anagement Parameters for 10 Mb/s Operation and Associated Power Delivery over a Single Balanced Pai

Cl 00 SC 90.1 P 0 L 0 # r01-90

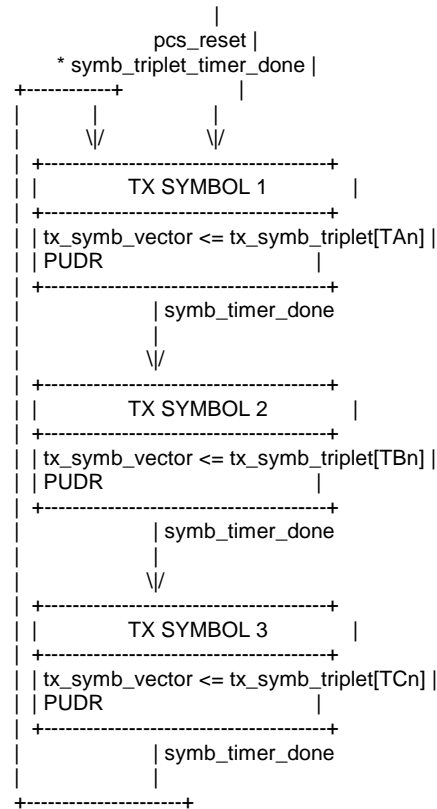
Comment Type TR Comment Status A State Diagram

Is it correct that 'The PCS Transmit function shall conform to the PCS Transmit state diagram in Figure 146-5 ...' and that 'In each symbol period, PCS Transmit generates a symbol An provided to the PMA ...'? The PCS Transmit state diagram in Figure 146-5 changes state based on STD being true, with STD being an alias for symb_triplet_timer_done, and the output of the PCS Transmit state diagram is tx_symb_triplet which is defined in subclause 146.3.3.1.1 'Variables' as 'A triplet of ternary symbols generated by the PCS Transmit function after 4B3T encoding.'

I think the problem is that there is another function within the PCS Transmit function that is missing from the PCS Transmit state diagram in Figure 146-5, the 'multiplexor' shown in Figure 146-6 'PCS transmit symbol generation'. This 'multiplexor' function operates at the symbol clock rate and serialises the tx_symb_triplet code-groups output by the PCS Transmit state diagram into individual symbols.

This may also explain when subclause 146.3.3.1.3 'Timers' defines the symb_timer that is not used in the PCS Transmit state diagram in Figure 146-5.

[4] Add a new subclause 146.3.3.2.2 titled 'Timers'. Move the symb_timer definition from subclause 146.3.3.1.3 Timers to this new subclause.

[6] Insert a new Figure 145-6 shown below (view using a non-proportional font such as courier), renumbering the following figures as required.

[7] Add text to subclause 146.3.3 'PCS Transmit' that reads 'The PCS Transmit function shall conform to the PCS Transmit state diagram in in Figure 146-5 and the PCS Transmit multiplexor state diagram in 146-6, and their associated state variables, functions, timers, and messages.'
